SOUTH CAROLINA ELECTRIC & GAS COMPANY

Subject: Virgil C. Summer Nuclear Station  
Docket No. 50/395  
Operating License No. NPF-12  
Seismic Confirmatory Program

This letter serves to transmit formally ten copies of the responses to Staff questions discussed on April 28, 1983, and the further questions contained in the meeting summary. The initial questions are numbered 1-6 as in the Staff's letter. The questions labeled 1 and 2 in the NRC's meeting summary are herein labeled 3A and 2A respectively.

FIGURE 1.1 Vertical component seismograms and Fourier spectra for Test 5, shot 8 (50 ft depth; left) and shot 6 (210 ft depth; right) recorded on the hydroplant foundation (HP).

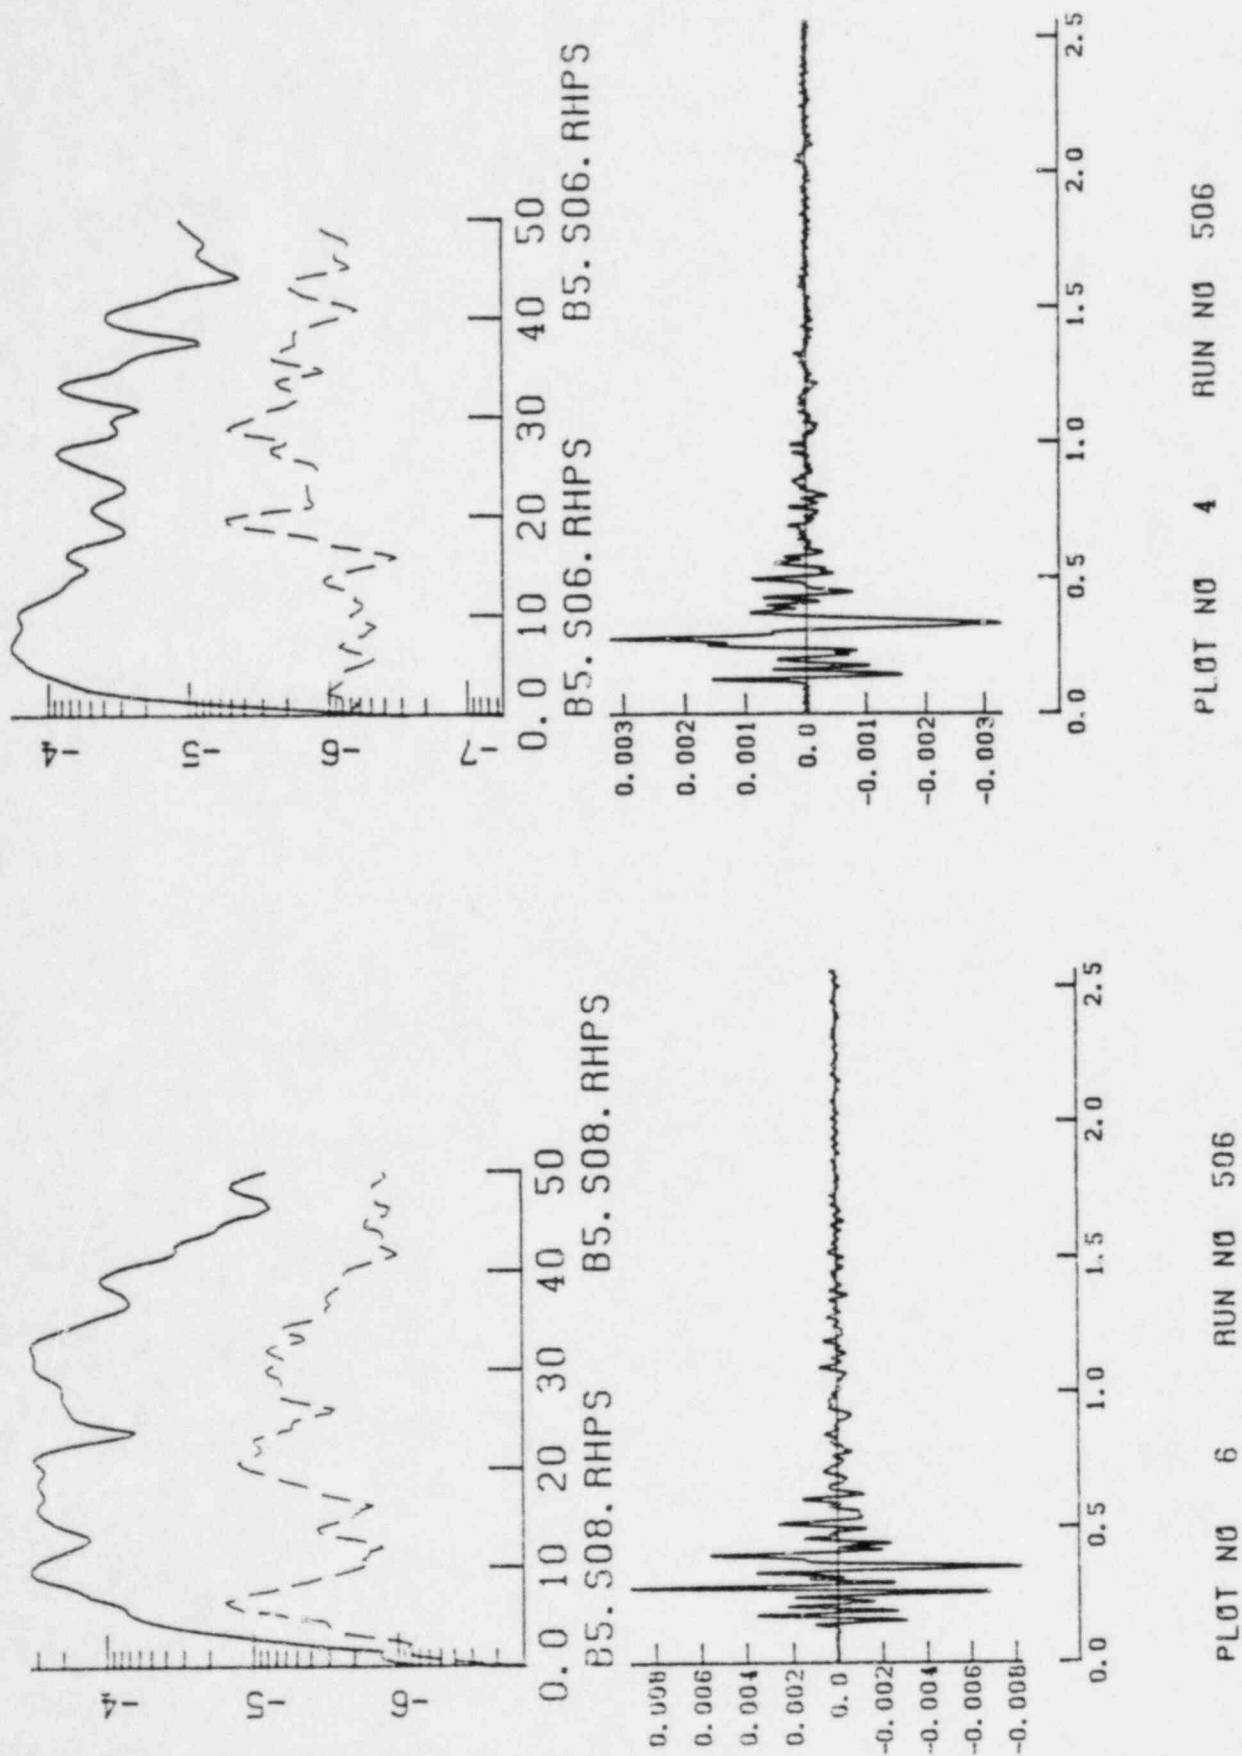
Question 1. Considering (a) propagation path, (b) soil amplification, (c) soil-structure interaction and (d) scattering, what biases in the relative responses of the foundation and free-field sites could be introduced by the shallowness of the explosion sources, compared to the average depth of reservoir - induced earthquakes? (Refer to Joyner's letter). Justify or modify the estimated reduction factors in light of your answer.

The differences between the signals generated by shots in saprolite and rock are illustrated in Figures 1.1 - 12. Hydroplant signals and spectra for shots 6 and 8 are shown in Figures 1.1 - 3. Shot 8 was at a depth of 50 ft in saprolite and 16 feet above bedrock, while shot 6 was 100 feet below the

Figure 2.16 Auxiliary Building foundation response spectra obtained from transverse component transfer functions for Test 4, shot 4 with random phase, observed phase and zero phase (in ascending order). Top trace is the response spectrum of the unfiltered 90° component 1979 accelerogram.

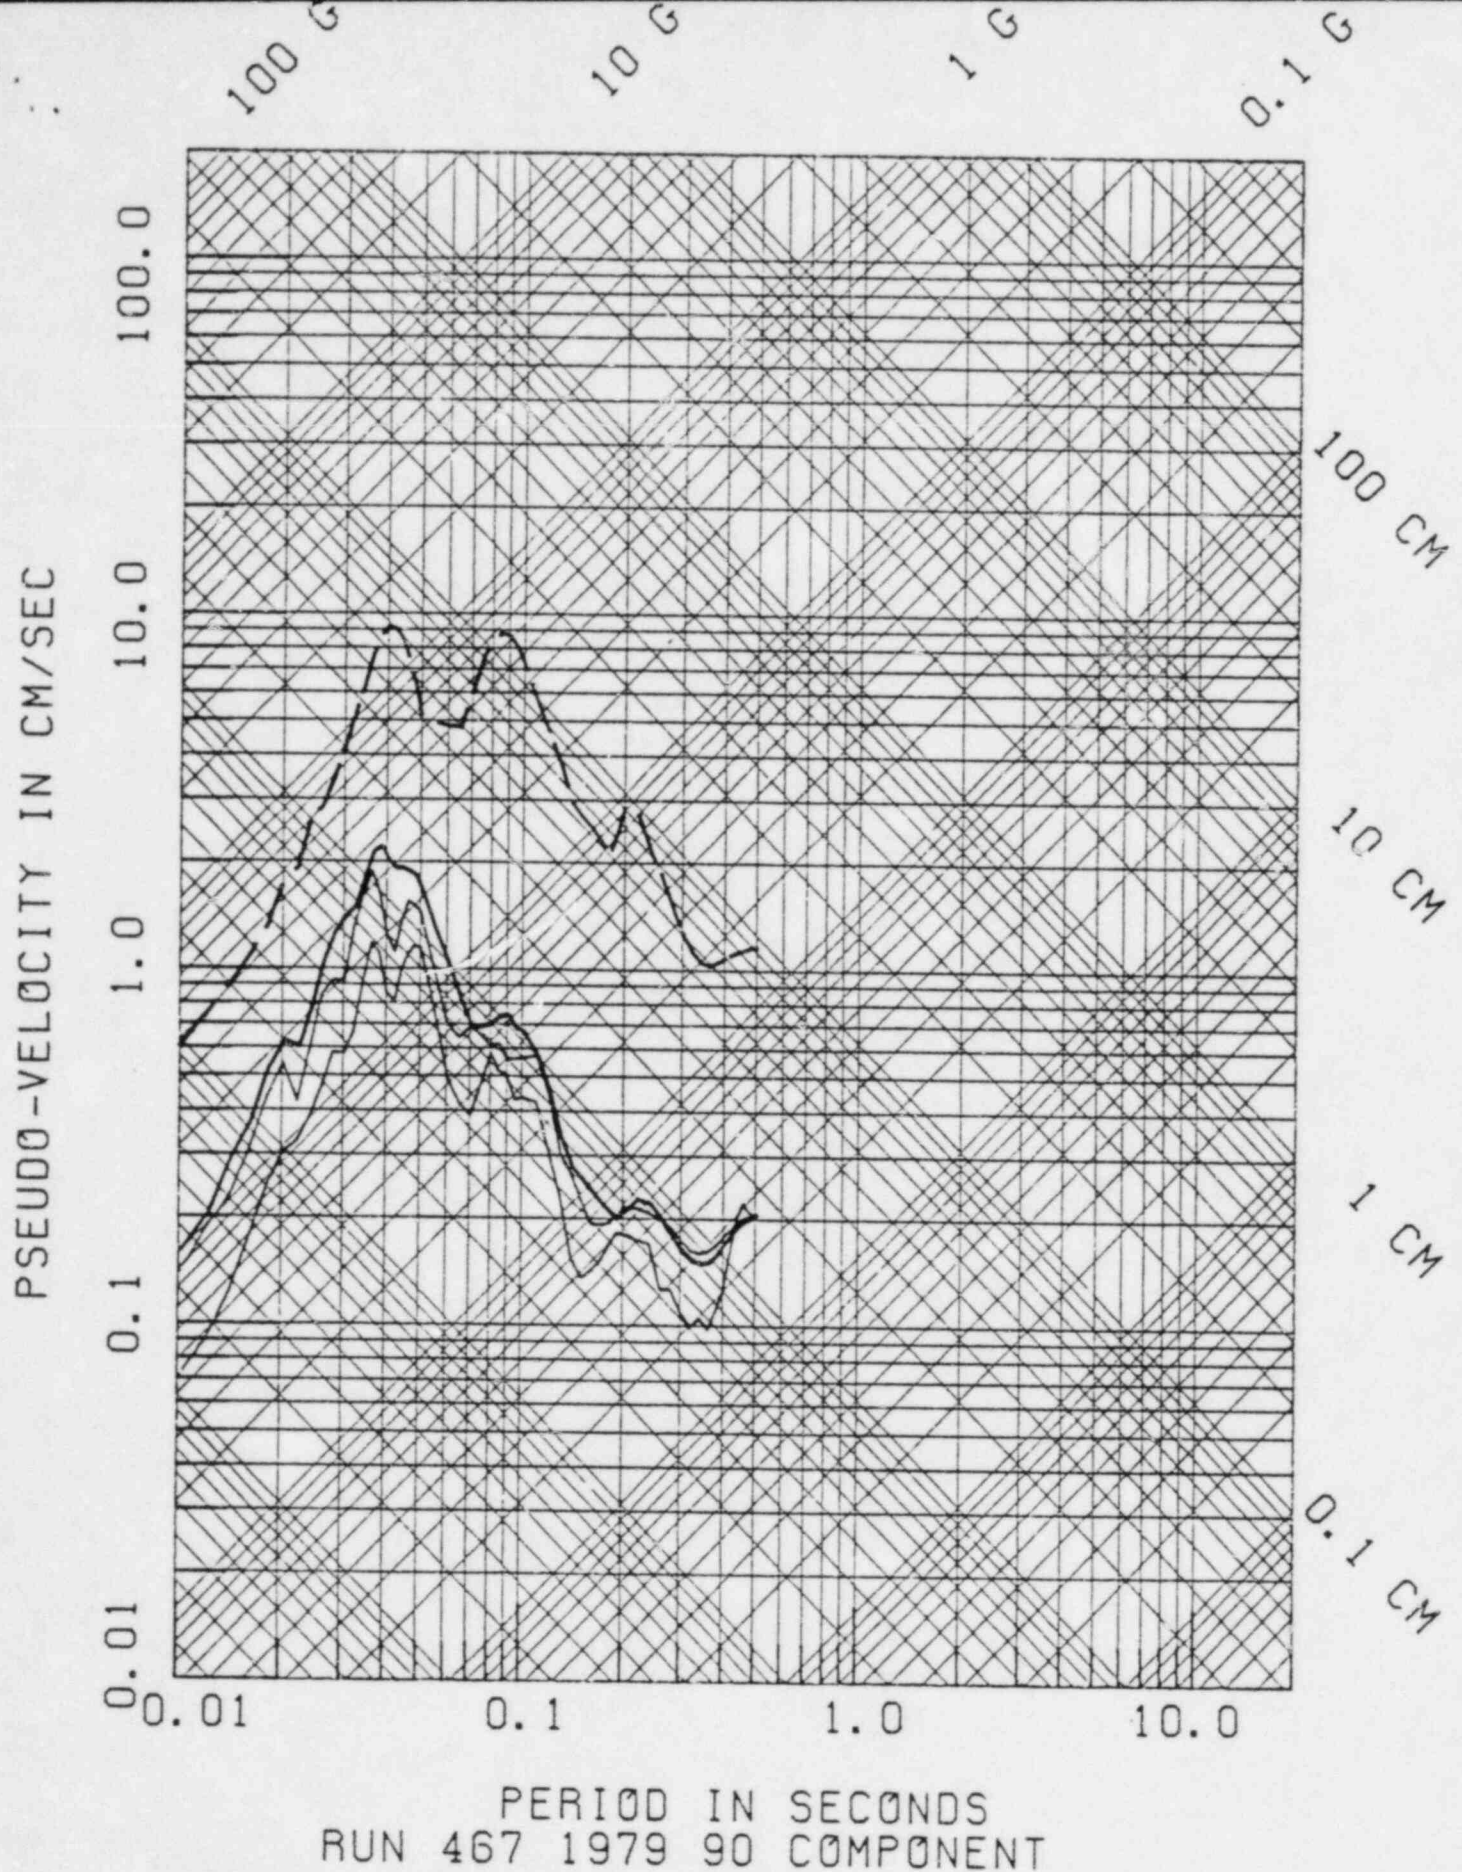
Question 2. How sensitive are the final response-spectra reduction factors to the assumption of zero-phase shift for the foundation-to-free-field transfer functions? Justify or modify the estimated reduction factors in light of your answer.

Figures 2.16 and 2.17 show the result of passing the filtered 90° and 180° component seismograms through a response spectrum algorithm (5 percent damping). The dashed trace gives the response spectrum of the input seismogram. The heavy solid traces show the result produced by the zero-phase filtered seismograms. The other two traces give the results for the observed and random phase seismograms. The zero-phase spectrum almost completely envelopes the other two. In each case the zero-phase spectrum is highest and the random-phase spectrum is lowest. These figures depict the sensitivity of computed response spectra to the phase shift assumption.

FIGURE 2A.1 Envelopes of band pass filtered records for Test 3, shot 2, at free-field site F1 (solid lines) and Auxiliary Building (dashed lines). Left, radial; right, transverse.

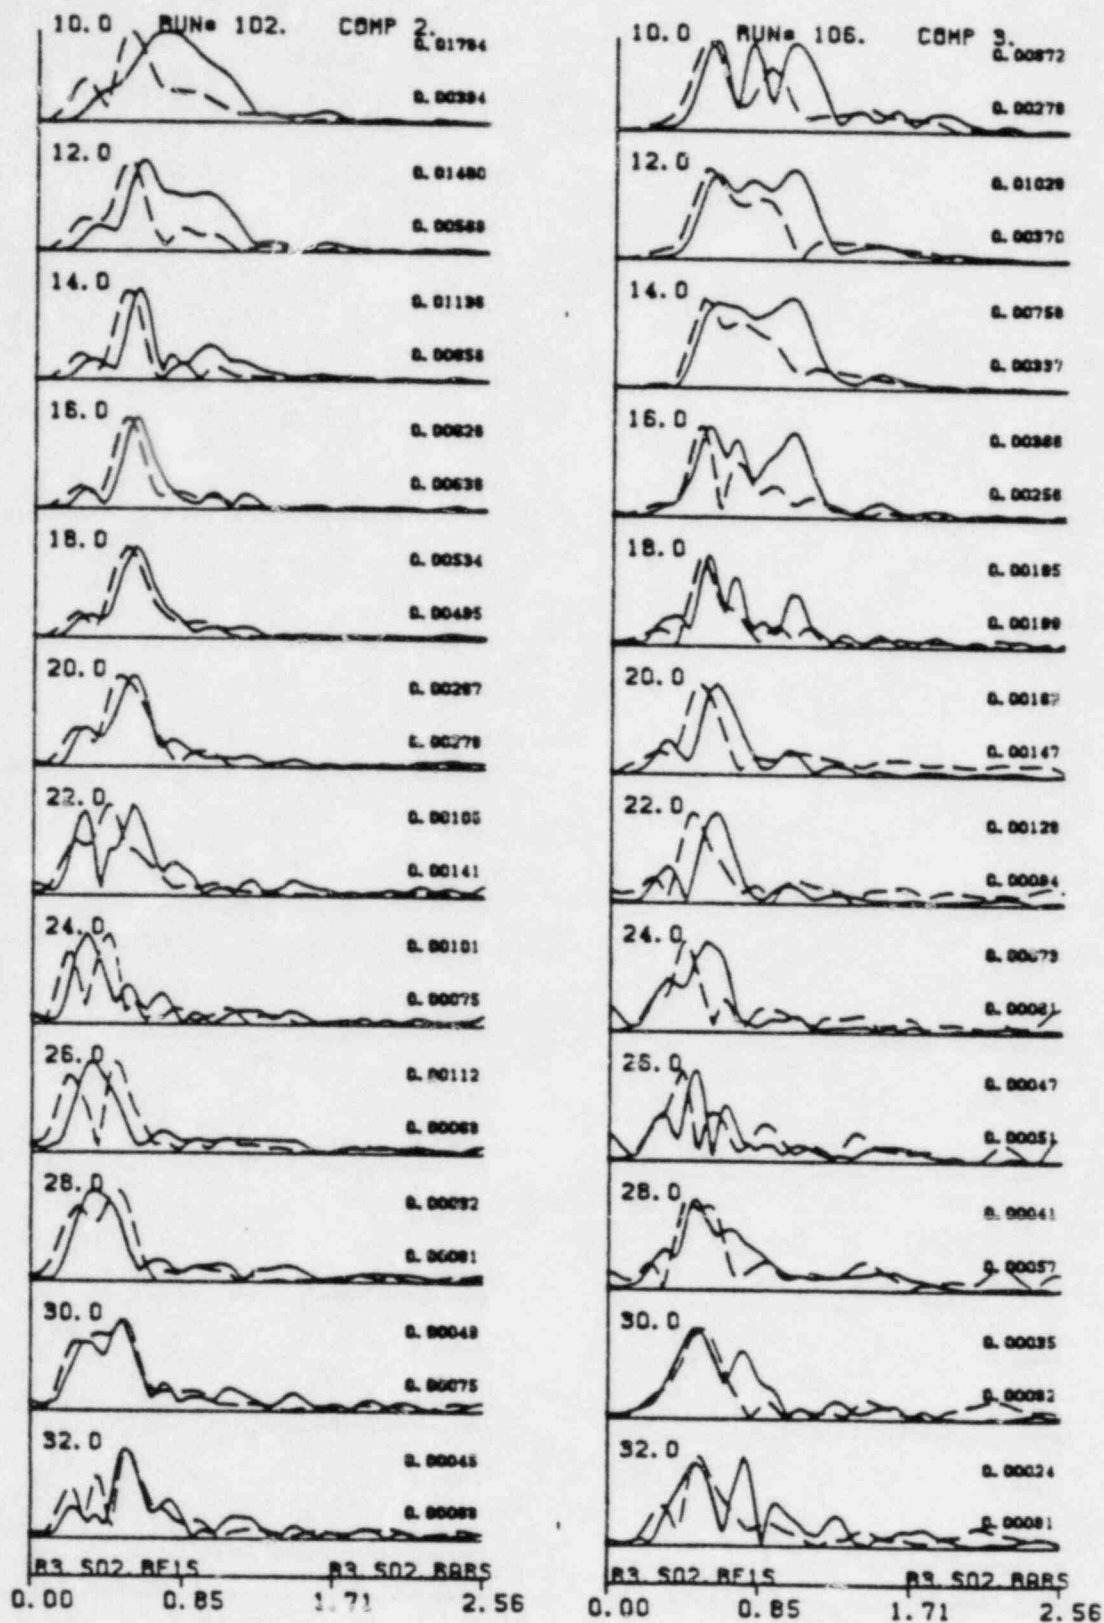
Regarding the sensitivity of the results to assumptions about phase response, the Licensee should calculate upper-bound reduced response spectra for computed foundation motions that have been processed with a spiking filter (e.g. Robinson, 1978); the processed signals will have the same amplitude spectra but will be compressed in time as much as possible. Alternatively, the Licensee should demonstrate some other upper bound, given that the pad-to-foundation transfer function may not represent a physically realizable filter.

Auxiliary Building durations for Test 3, shot 2 are compared with those for free-field sites F1, FR, F6, and F3 in Figures 2A.1 - 4. For frequencies above 15 Hz, there is no systematic difference between Auxiliary Building and free-field durations. The same is the case for the Diesel Generator Building and Service Water Pumphouse data, shown in comparison with free-field site F3 in Figures 2A.5 and 2A.6. Note that in some cases foundation and free-field durations are the same over the entire band 10 - 32 Hz (e.g., Figure 2A.4, transverse component, and Figures 2A.5 and 6, radial components).

Figure 3.1  
FREE-FIELD / PAD SPECTRAL RATIO,  
COMPUTED GEOMETRICALLY AND ARITHMETICALLY

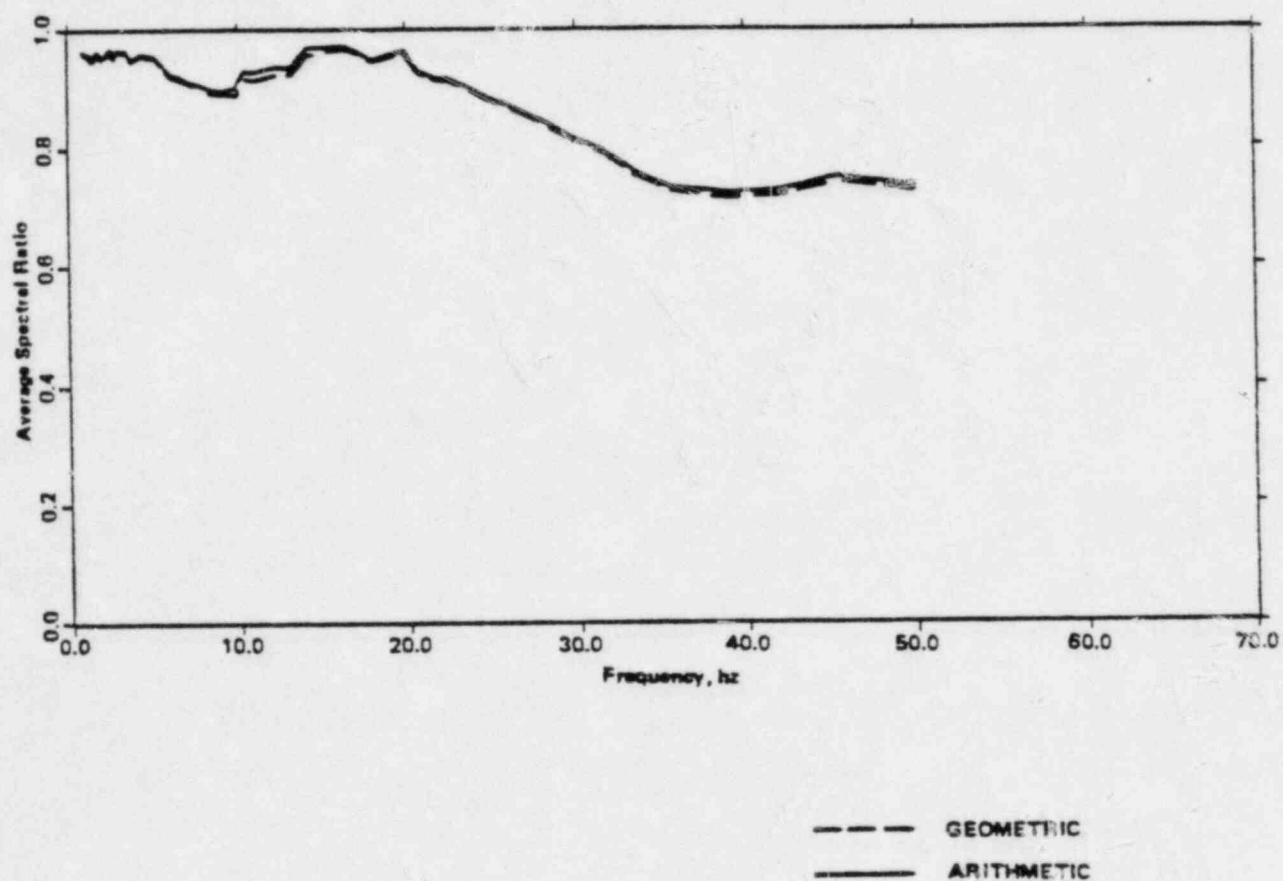
Question 3. Justify the statement on page 28 of Appendix B that "lognormal statistics are appropriate for use here"; document the actual distribution of ratios about the mean. Explain why spectral ratios are averaged geometrically in Appendix B and arithmetically in Appendix A. Justify or modify the estimated reduction factors in light of your answer.

In the case of the soil-pad interaction study (Appendix A), the coefficient of variation of the pad/free-field spectral ratio is small at each frequency. Thus the average reduction factors can be computed either arithmetically or geometrically, and similar results will be obtained. This is illustrated in Figure 3.1, which shows average spectral ratios computed by each method.
